RE: **Lot 19, Block 6, Unit 19**
8000 Camino Alto NW
SAD 228, Volcano Cliffs Subdivision
Grading and Drainage Plan
Engineers Stamp Date 6/13/19 (D10D003B19)
Pad Certification date 12/9/19

DRAINAGE AND TRANSPORTATION INFORMATION SHEET (REV 09/2015)

RE: Pad Certification by Engineer of Record (D10D003B19)

GRADING AND DRAINAGE PLAN
8000 CAMINO ALTO NW
LOT #19, BLOCK #6, VOLCANO CLIFFS UNIT #22

GRADING AND DRAINAGE PLAN

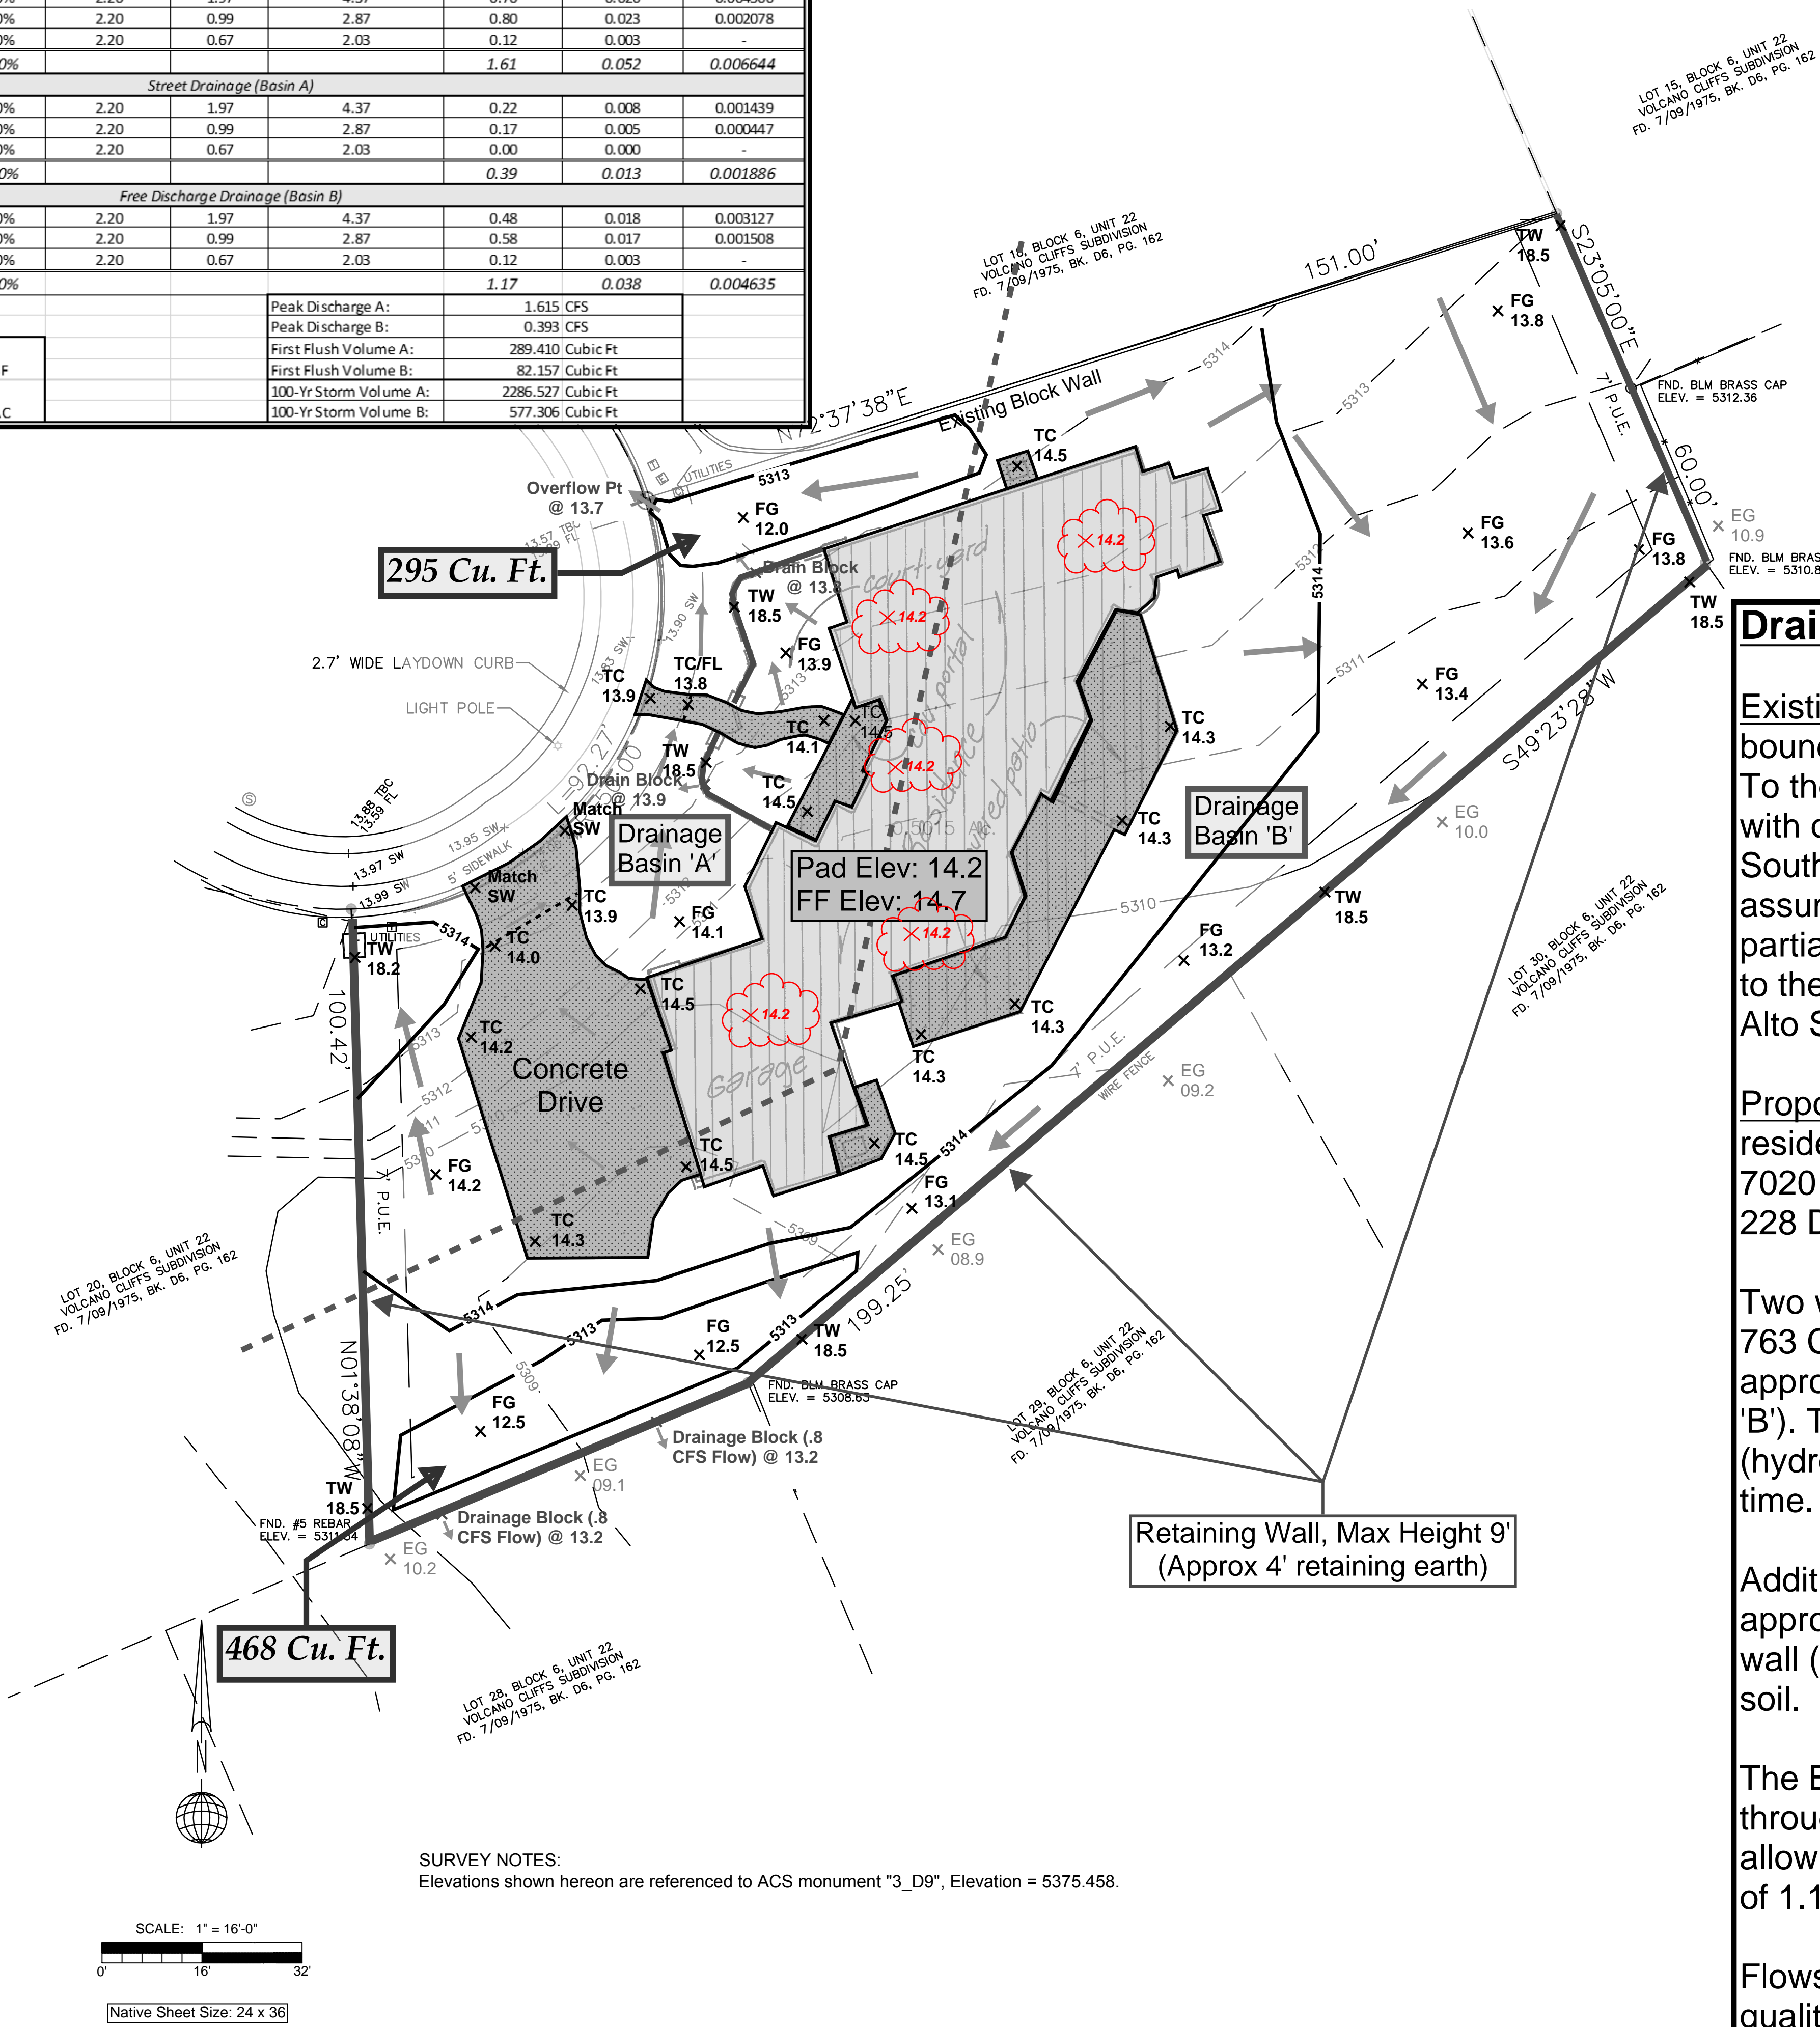
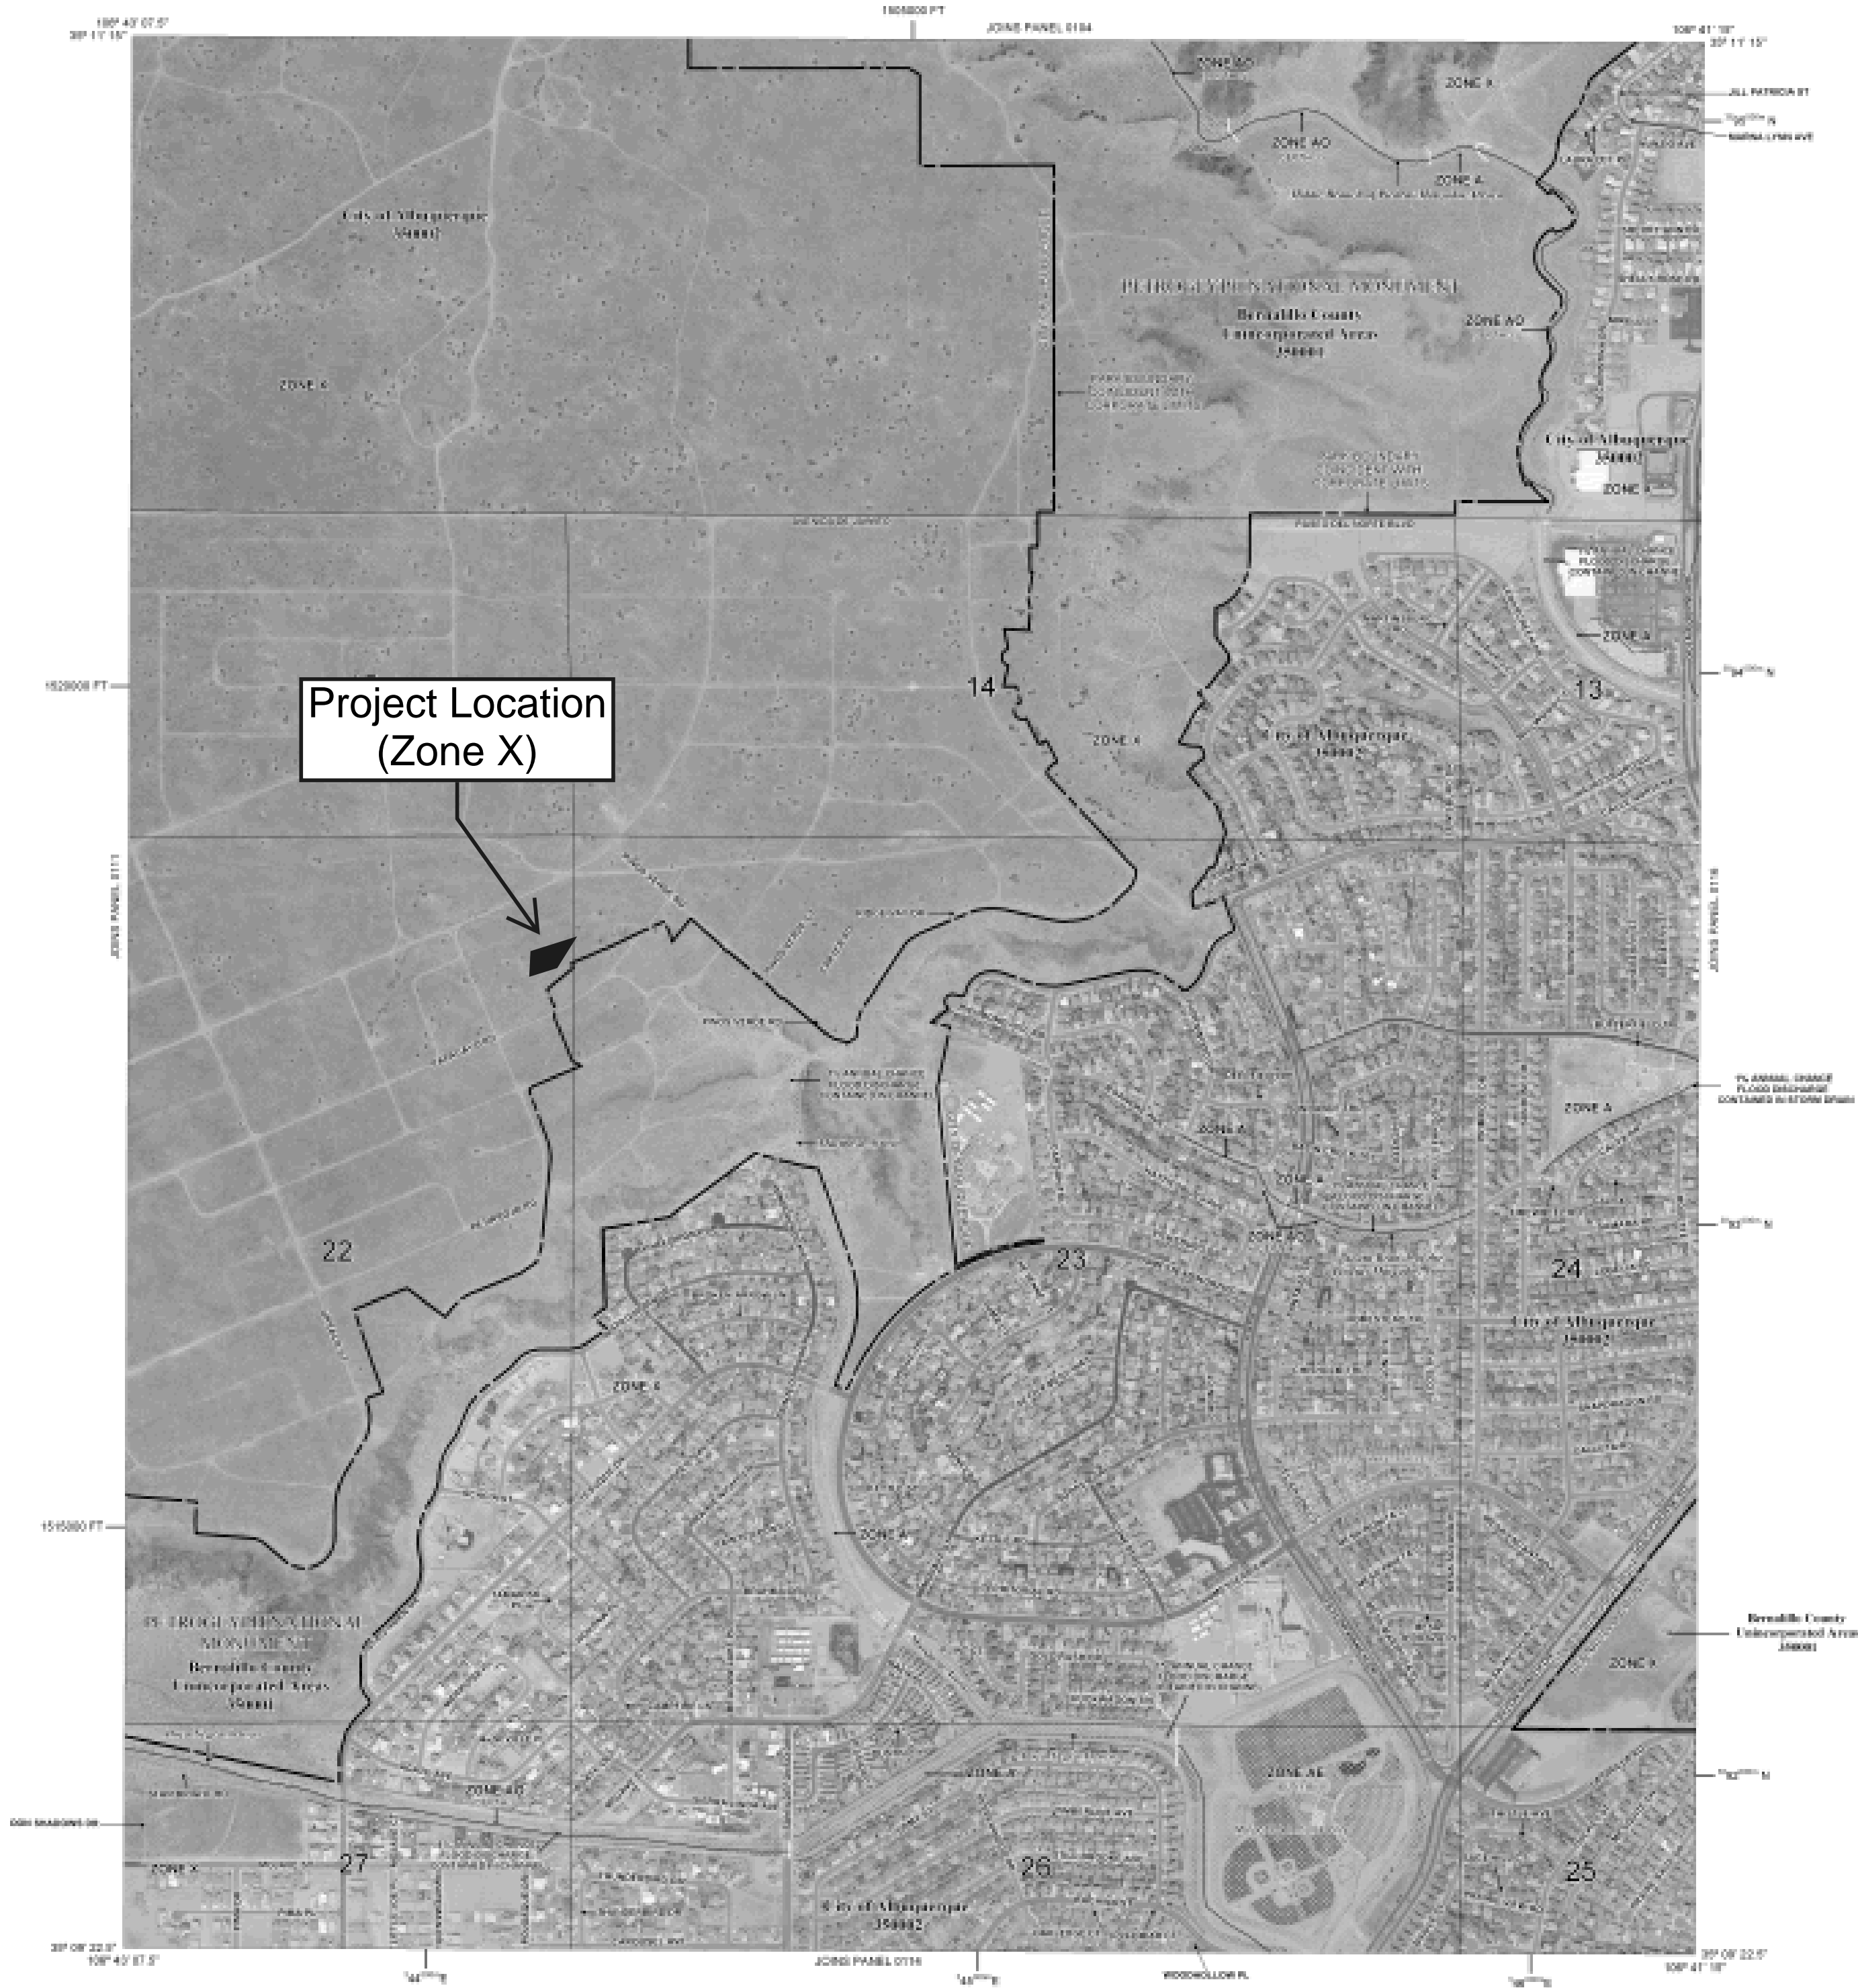
Based upon the information provided in your submittal received 12/9/19, this plan is approved for Building Permit.

Advise the owner/contractor that a separate wall permit must be obtained and this approved grading plan dated 6/13/19, pad certification dated 12/9/19 must be provided with the wall permit application.

Advise the contractor/owner that the ponds must stay in place or CO will not be granted.

Prior to Certificate of Occupancy release, Engineer Certification per the DPM checklist will be required.
